PLANNING BOARD AGENDA
January 13, 2026 – 6:00 p.m.
City Council Chambers, 60 Court Street

Re: PUBLIC HEARING/ SITE PLAN and FINAL SUBDIVISION REVIEW: 15 Academy Street (PID 230-132): Application by Gorrill Palmer on behalf of Auburn Town Center Apartments, LLC for the construction of a 53-unit residential development. This property is in the Traditional Downtown Neighborhood (T-4.2) district and will be reviewed under Chapter 60, Article XVI, Division 2 – Site Plan Review and Division 4 – Subdivision.

Re: PUBLIC HEARING/ SITE PLAN and PRELIMINARY SUBDIVISION REVIEW: 15 Academy Street (PID 230-132): Application by Gorrill Palmer on behalf of Auburn Town Center Apartments, LLC for the construction of a 53-unit residential development. This property is located in the Traditional Downtown Neighborhood (T-4.2) district and will be reviewed under Chapter 60, Article XVI, Division 2 – Site Plan Review and Division 4 – Subdivision.

Drawing No. **C-5.0**

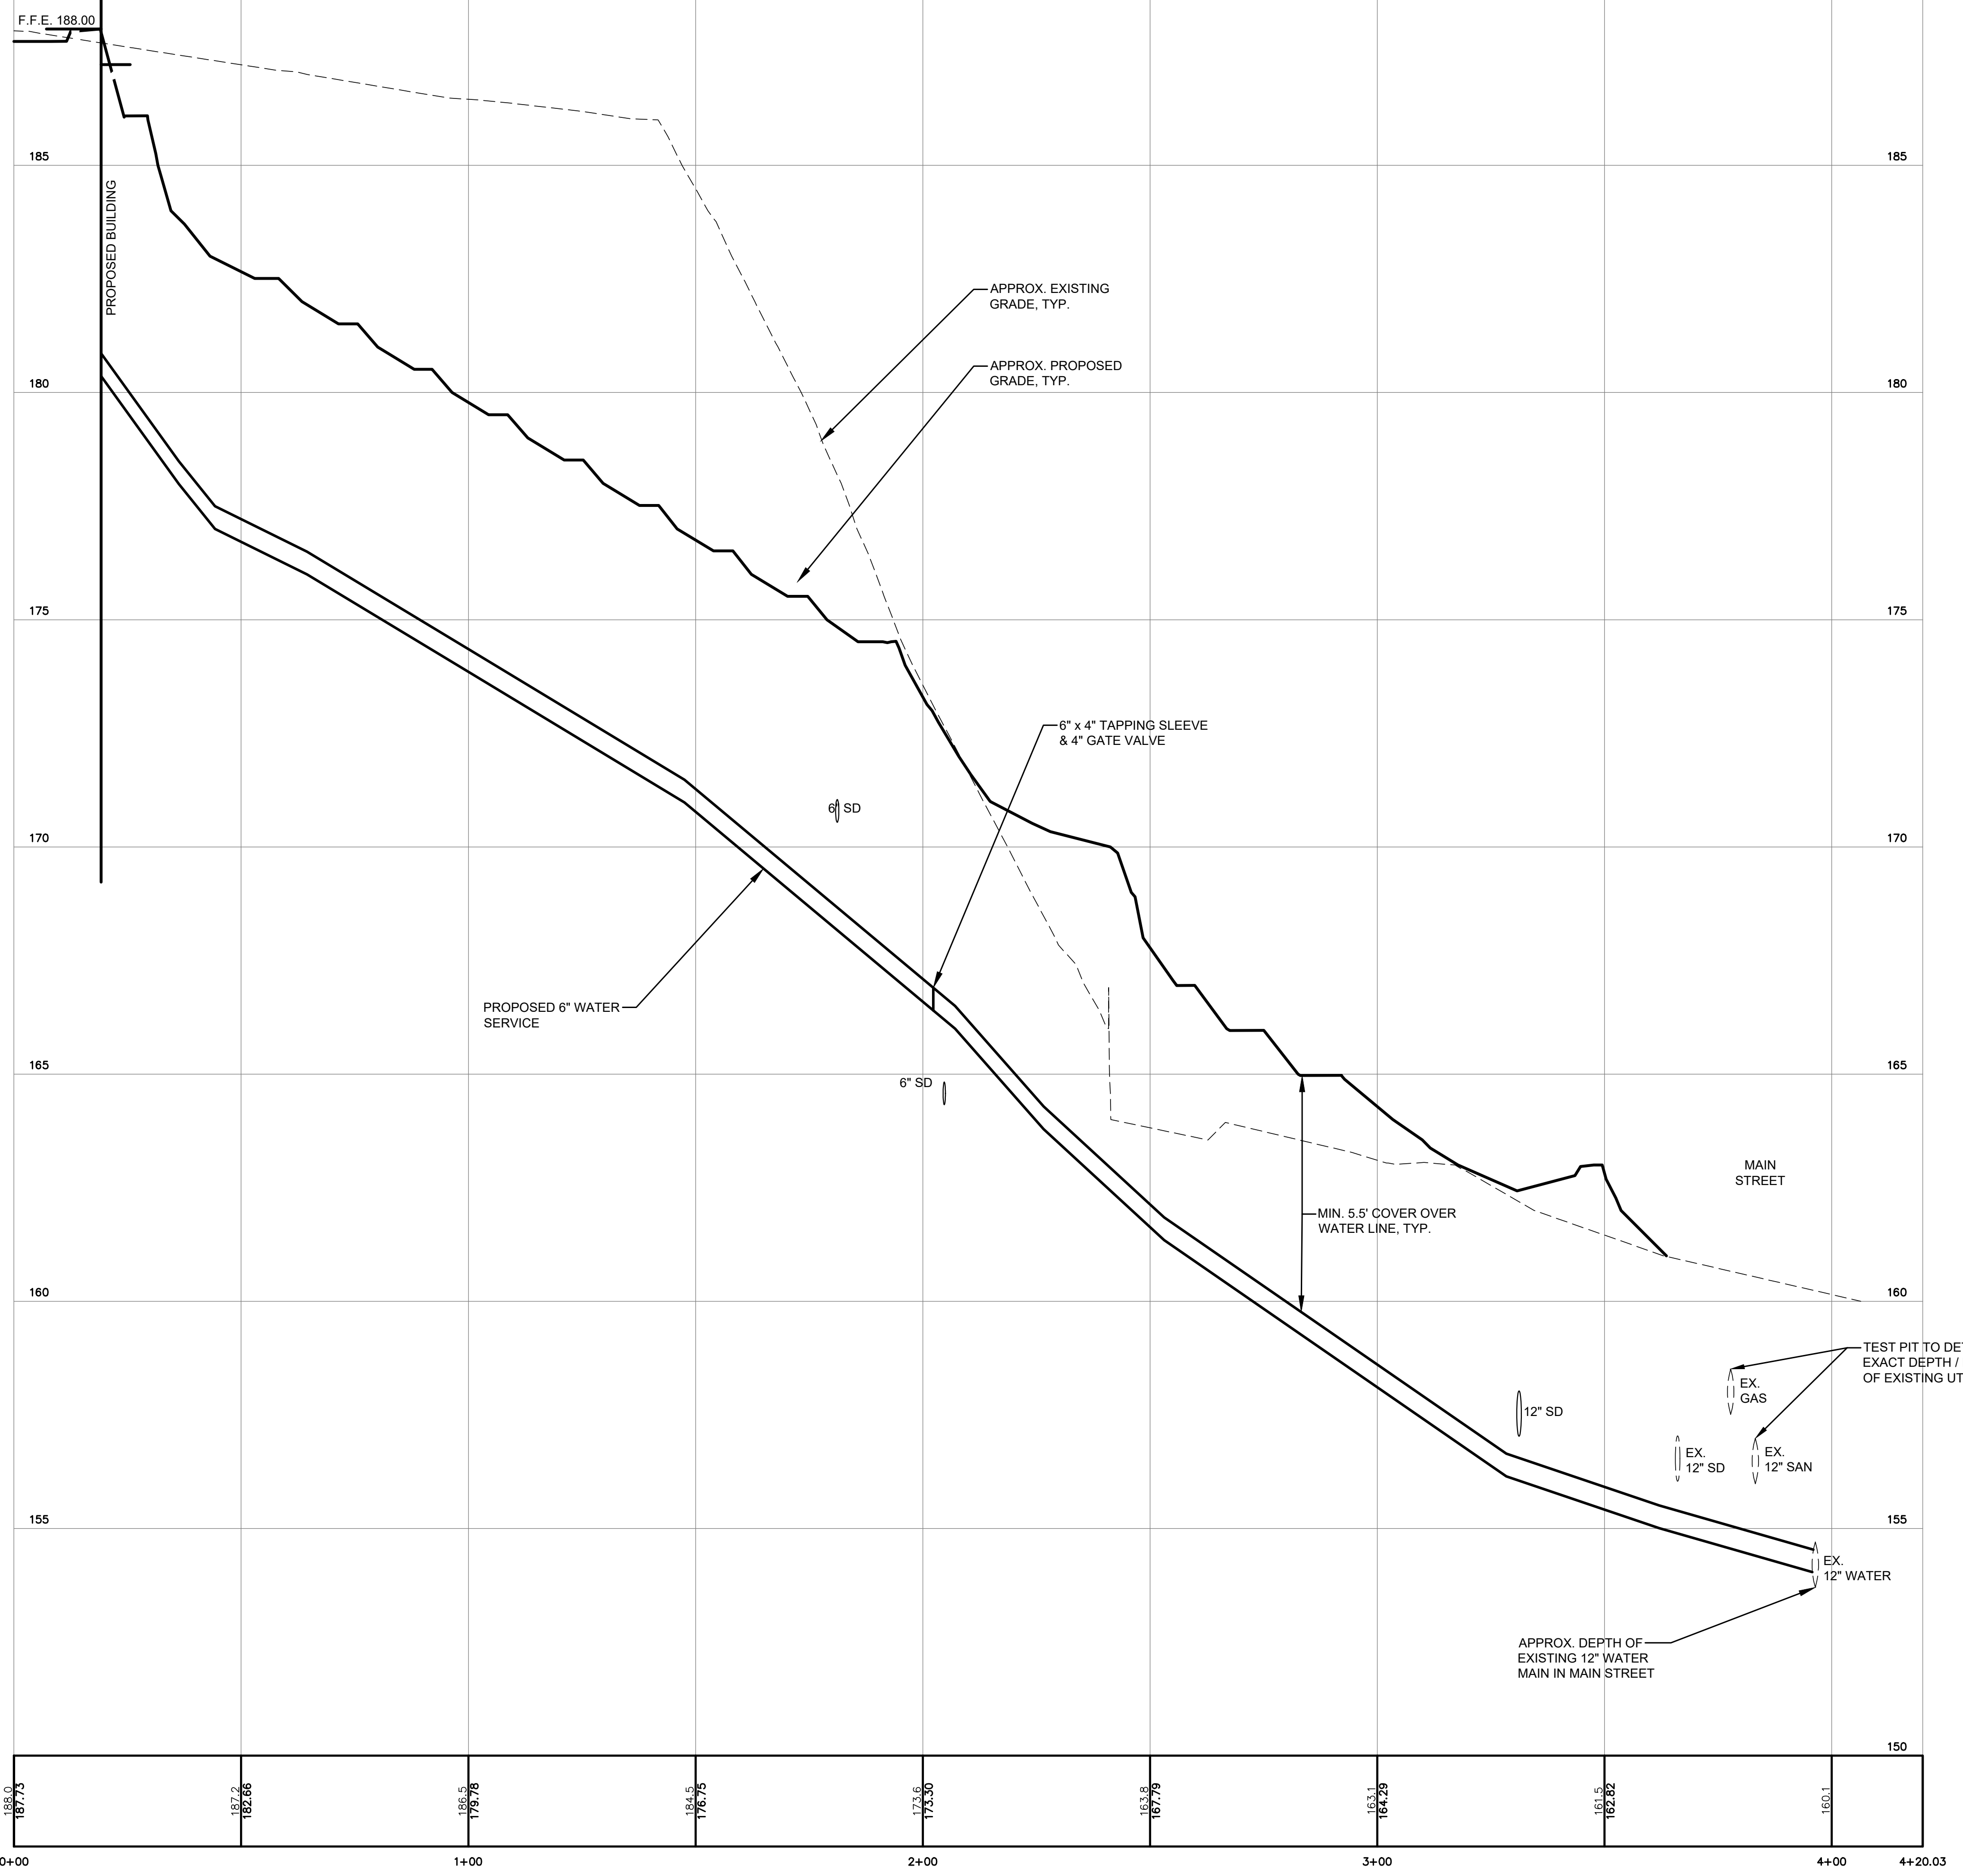
18. *Auburn Water & Sewer District (AWSD): Plans show both a 4" and 6" water main connection in Main Street. The drawings also show the 4" connecting to the 6" closer to the building on C-5.0, which may be an error. Recommend one connection in Main Street, splitting as shown near the building.*

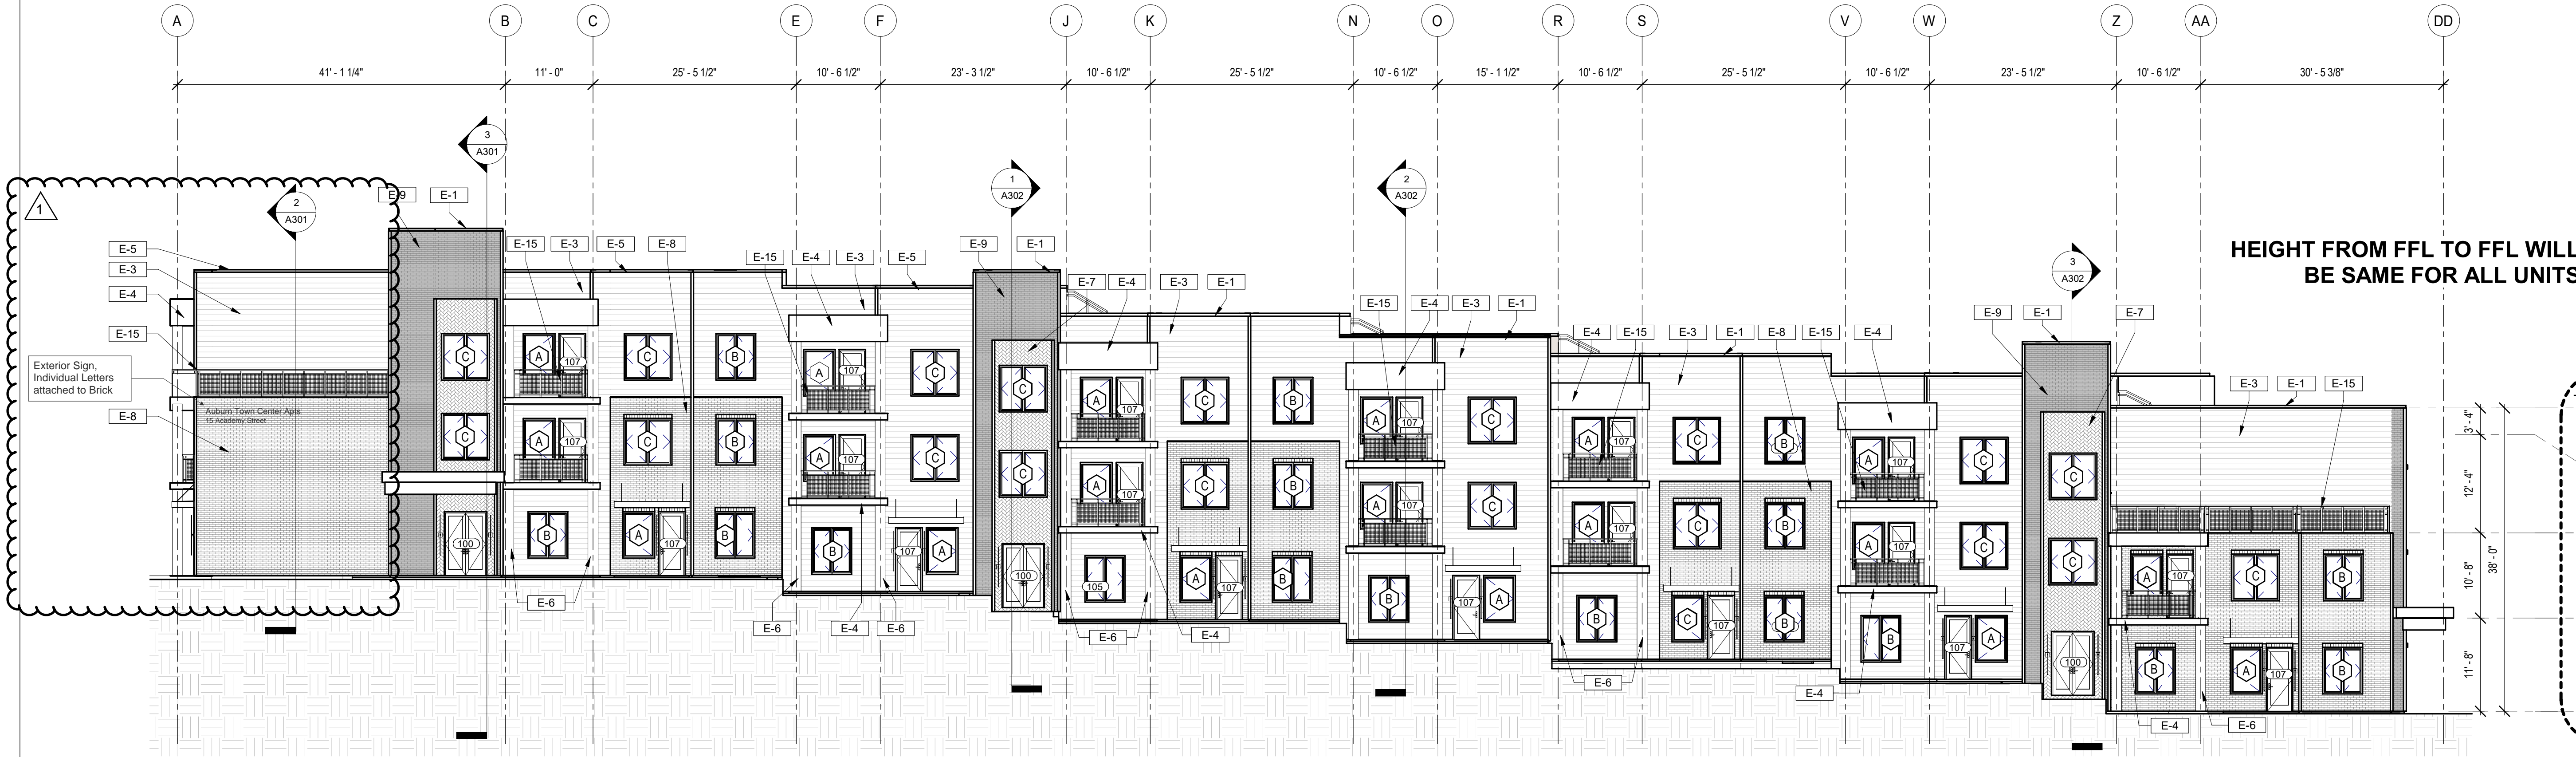
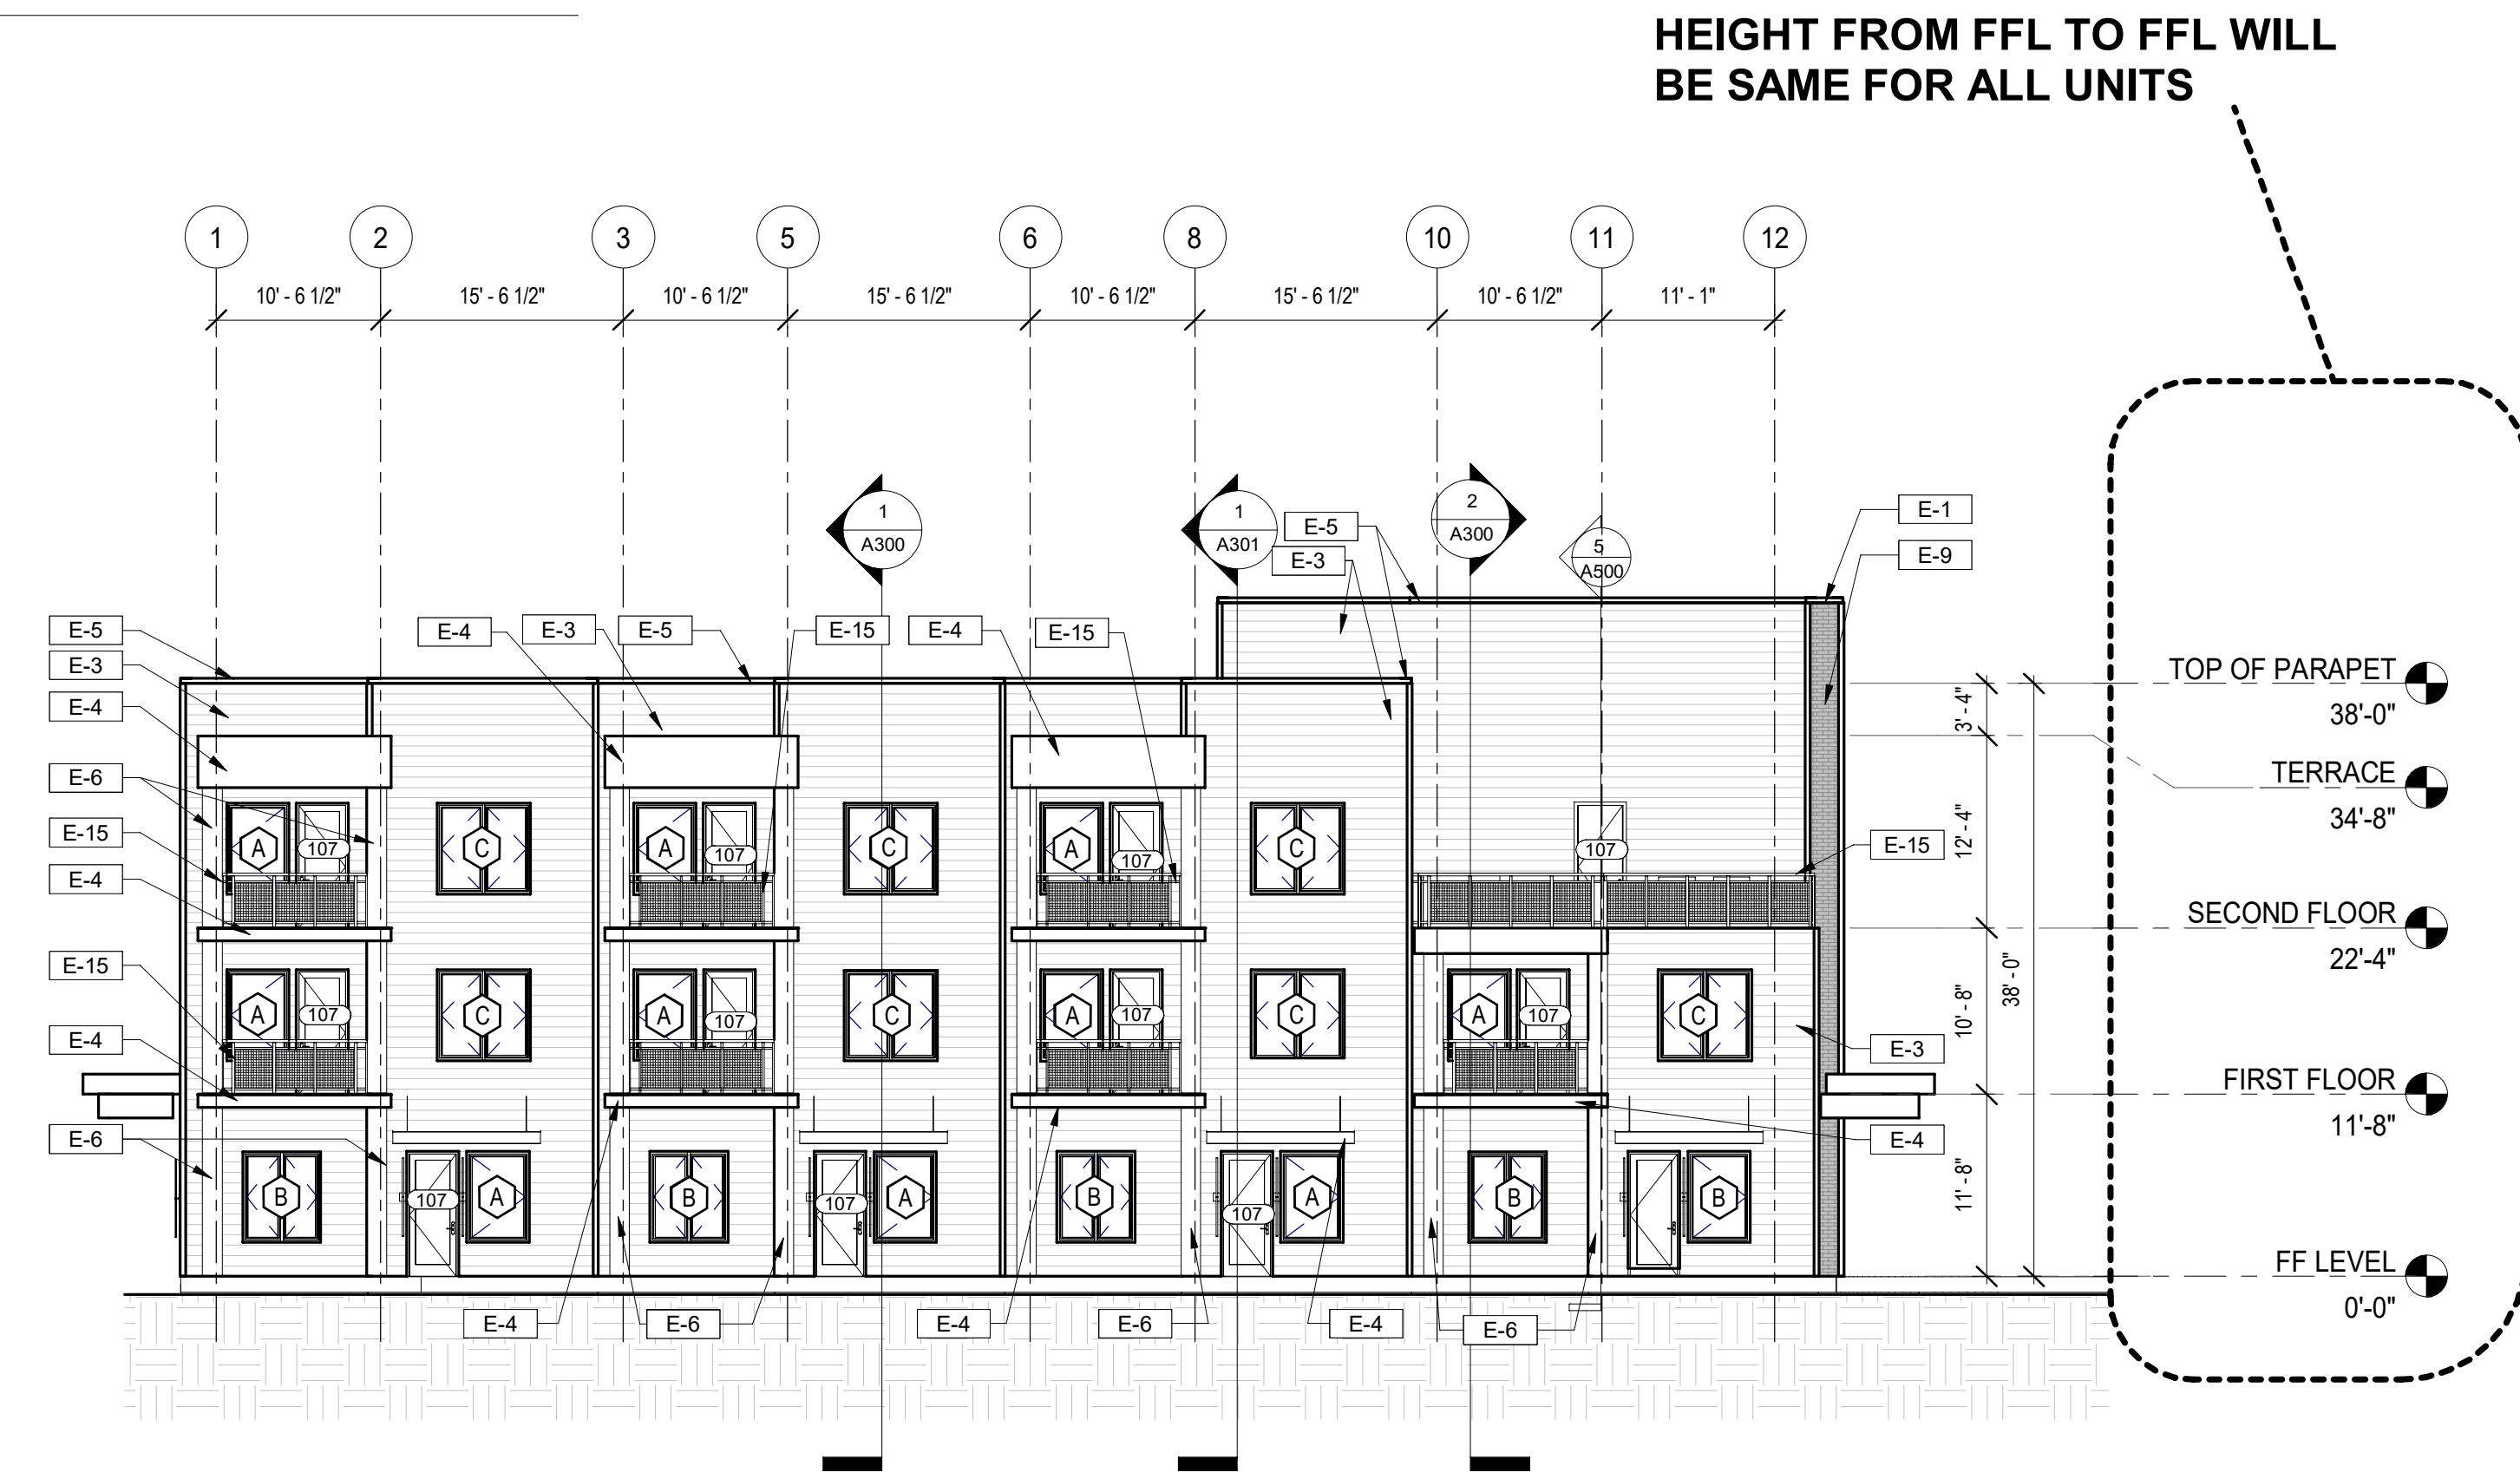
5. Waiver for Maximum Building Width
 - Concerns were raised about the requested waiver to allow a 276-foot building width along Academy Street.
 - Revised architectural plans have been submitted, including updated elevation sheet A201, showing façade changes to comply with the form-based code and avoid blank wall violations.
